SS 701-WST2021 4700-5700 DT12 Harness Chaffing - PT Can Faults

WST 4700 - 5700 with DT12 Transmissions.

Figure 1: Transmission Control Harness routing points that require inspection/correction.

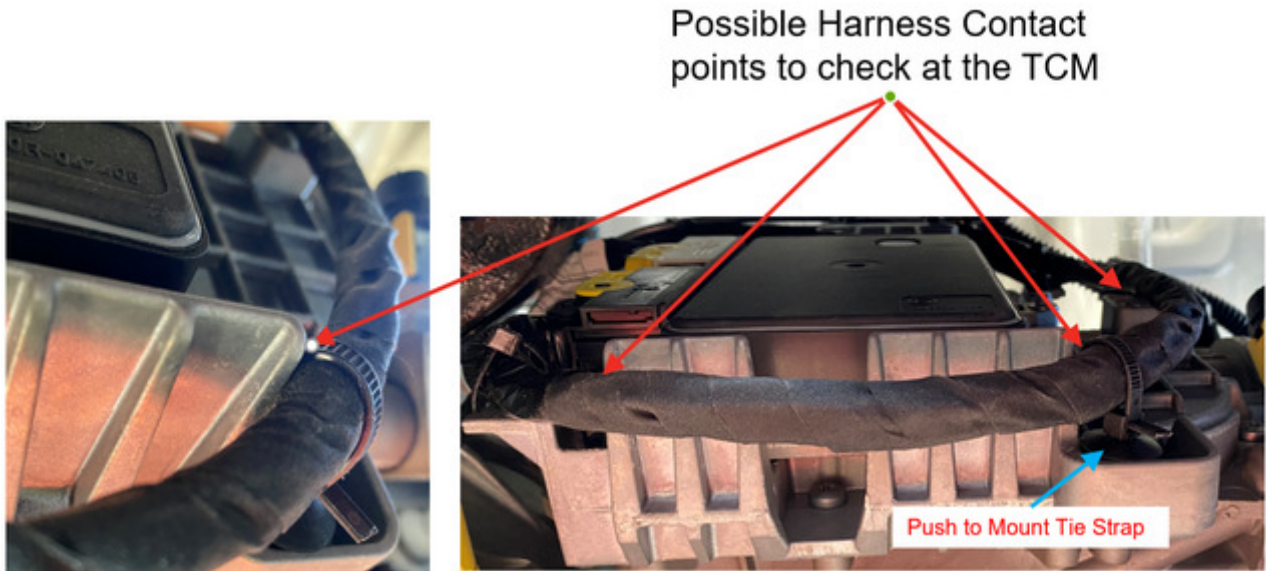
Transmission Control Harness rubbing/chaffing with TCM. Tie Strap push to mount specified for Harness routing-clipping may not stay in place causing Transmission Control Harness rubs/chafes with TCM at several points resulting in intermittent failures and triggering multiple PT Can Fault Codes if Harness is damaged. See Figure 1.

Figure 3: Updated Transmission Control Harness routing-clipping with addition of heavy duty wrap.

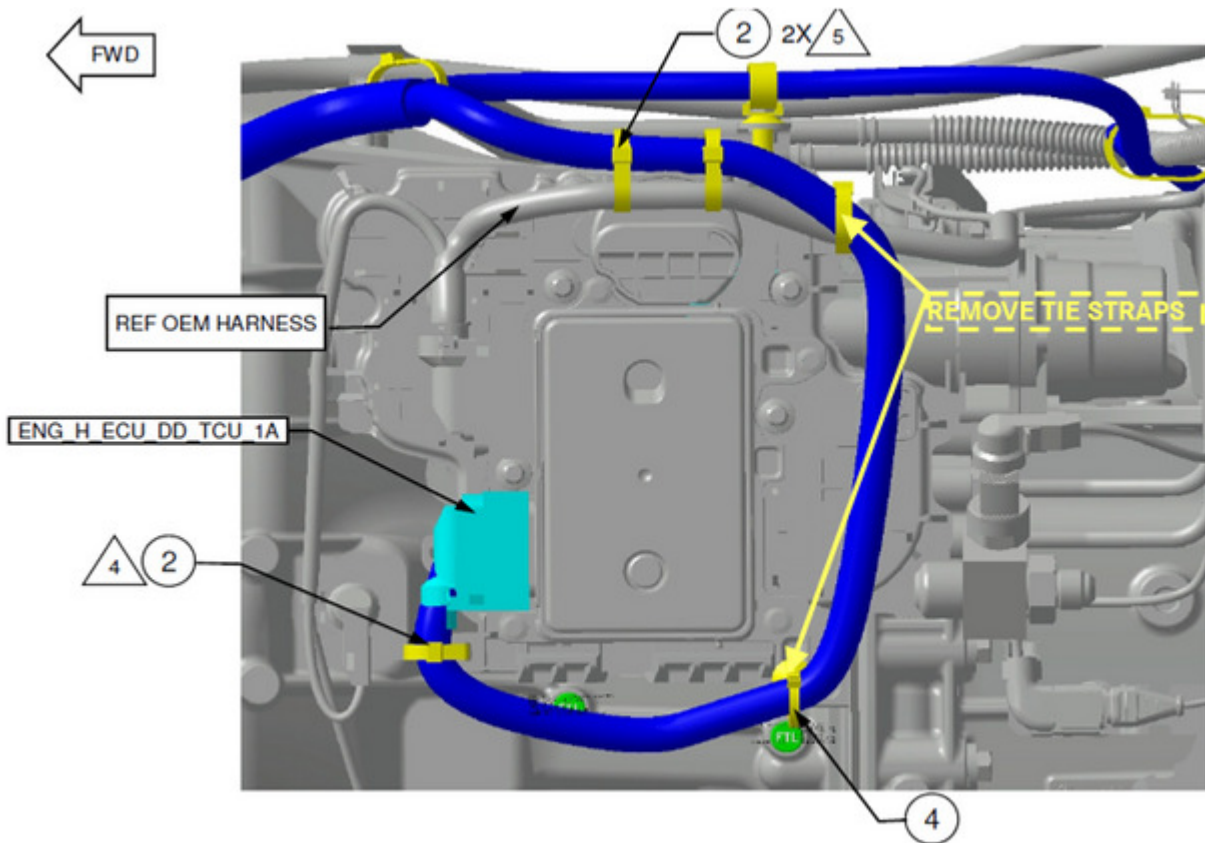
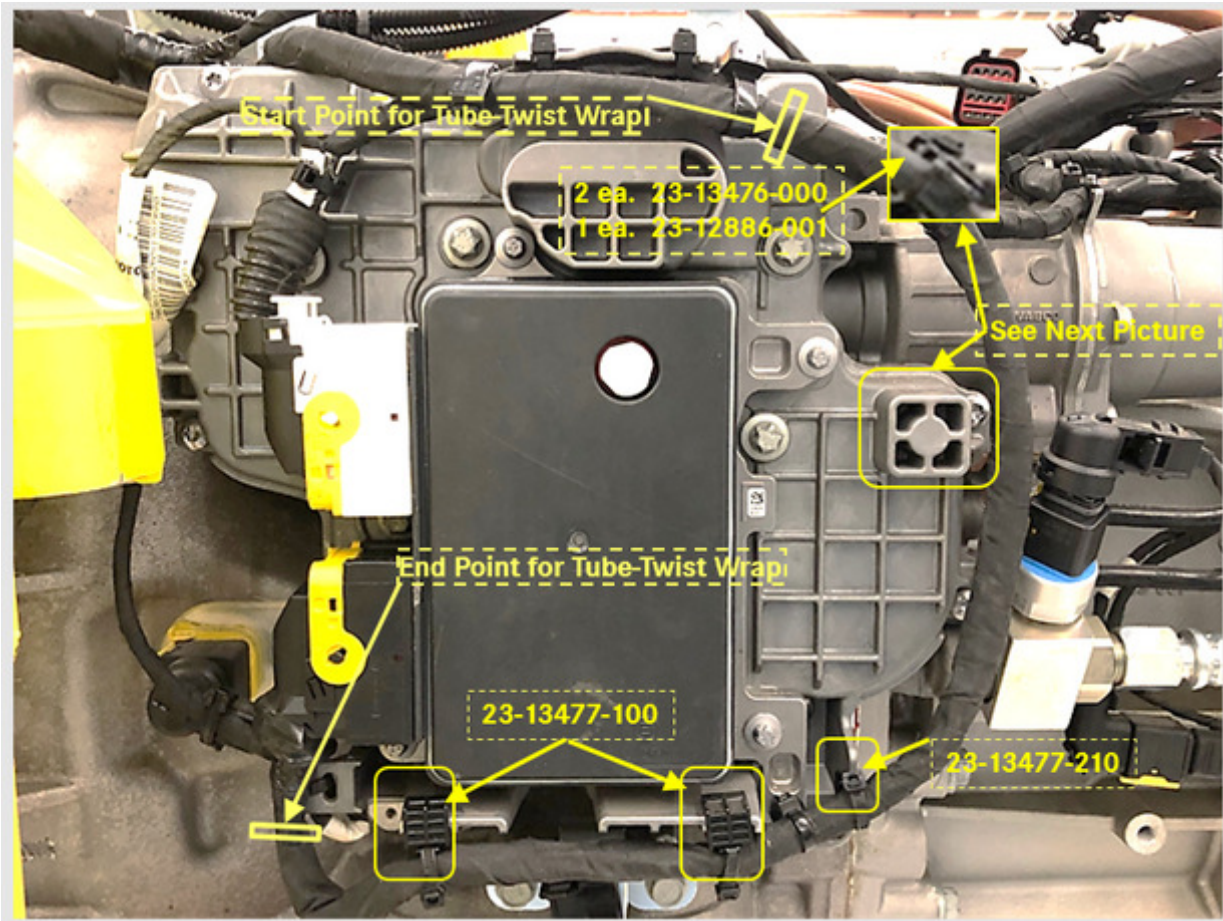
- Cut and remove tie straps used to attach Transmission Control Harness, items 2 and 4 shown in Figure 2. Inspect Harness for damages caused by rubbing / chaffing and repair as needed, refer to SB 54-290 for Harness repair instructions.

- 1 each 23-13477-210 tie strap with top centered push on clip
- 2 each 23-13477-100 tie strap with offset push on clip
- 1 each 23-12886-001 double strap swivel
- 2 each 23-13476-000 ½" wide tie strap
- 3 FT BEN 2421002503SCM TUBE-TWIST,BLK,DIA 25
- A/R Electrical Tape

- Add "Tube Twist" (Heavy Duty Wrap) from start to end point locations shown and secure with electrical tape to Transmission Control Harness, then route and clip to Transmission Control Harness using Tie Straps part numbers shown below at each location in Figure 3.

Figure 4: Check for clearance between TCM and Transmission Control Harness.

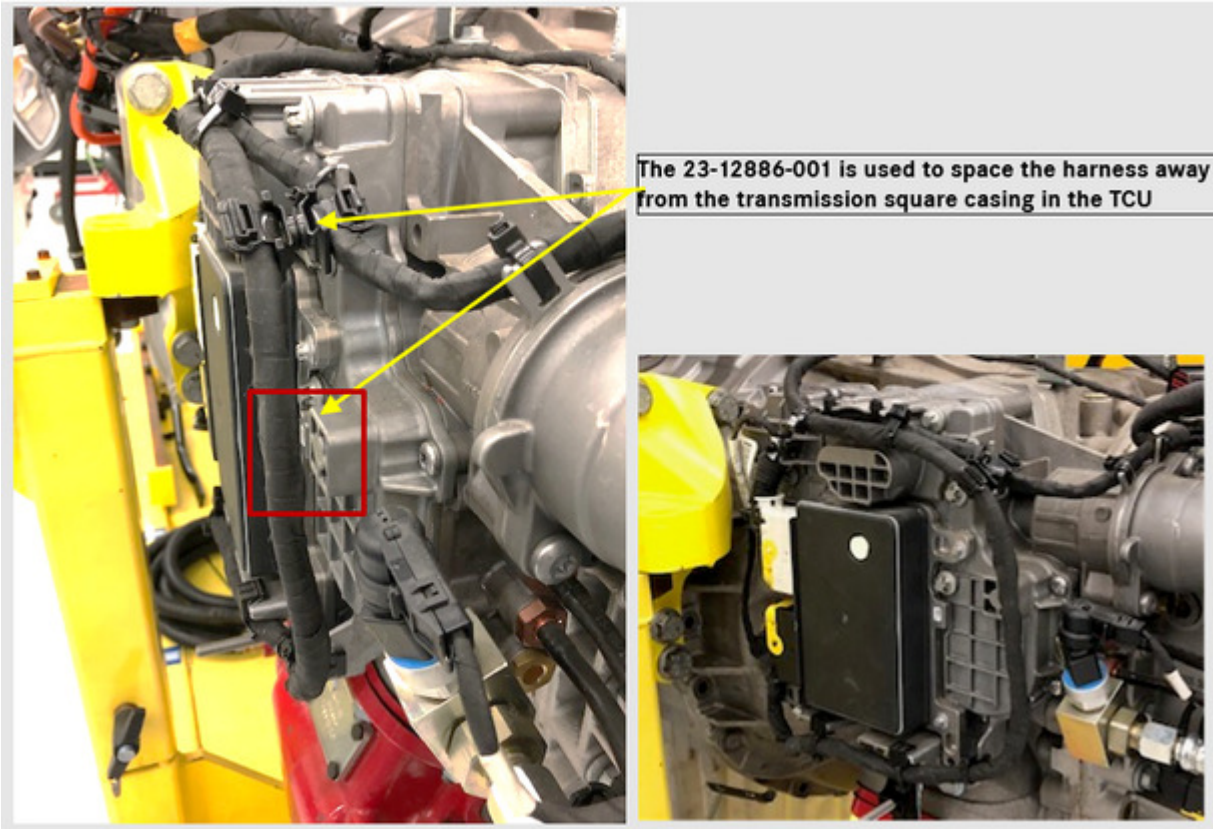
- Figure 3 and 4 show how to correct/update Transmission Control Harness installation.
